# ROD-230-1: Leith Street redetermination (RSO/17/13)

Final comments from Spokes – the Lothian Cycle Campaign, September 2019

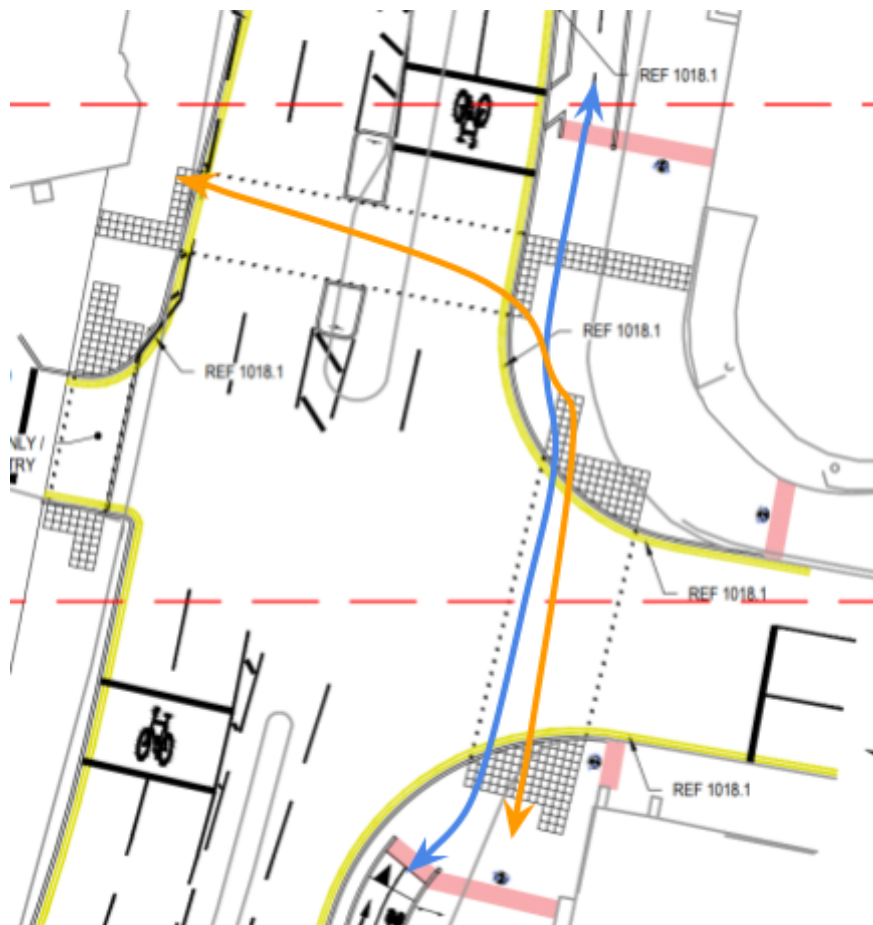
The Council should therefore be urged to investigate shorter term solutions to reduce the number of carriageway lanes necessary to support the turning movements at this junction and thereby free-up space for Southbound cyclists and a wider footway at the pinch point on the East side.

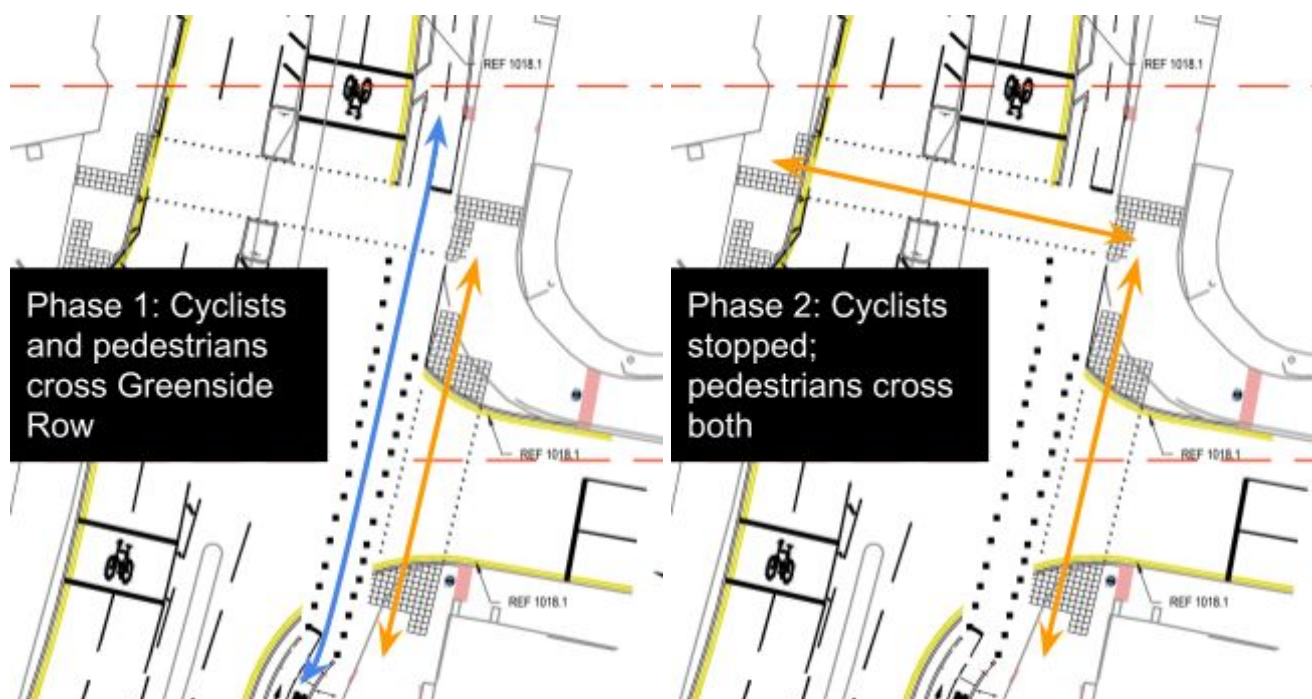
The question then is how to redesign the junction. As per our original objection, Spokes insist that the cycleway must be continuous across Greenside Row using a split crossing with no conflict between pedestrians and cyclists. The Council's comments on this in 6.4 say:

*If the cycleway had been segregated through the junction, it would have been necessary to either:*

- a) install an informal zebra crossing of the cycleway at the point where it crossed the pedestrian crossing of Leith St (option a); or*
- b) change the signalling so that the pedestrian crossing of Leith St operated at a different time in the signal cycle to the crossing of Greenside Row (option b).*

They then go onto discuss the problems with these options in 6.5 and 6.6 and we acknowledge these drawbacks. However, they completely fail to consider an option c where there are two phases:

1. A first where both cyclists and pedestrians can both cross Greenside Row at the same time, and pedestrians waiting to cross Leith Street wait.
2. A second where cyclists are stopped, and pedestrians can continue to cross Greenside Row, and may additionally cross Leith Street.

In this approach there is no need for a mini-zebra crossing of the cycleway as cyclists are stopped when pedestrians cross Leith Street, mitigating concerns about option a. But there still exists a phase where pedestrians may cross both Greenside Row and Leith Street at the same time, mitigating the concerns about pedestrian provision with option b.
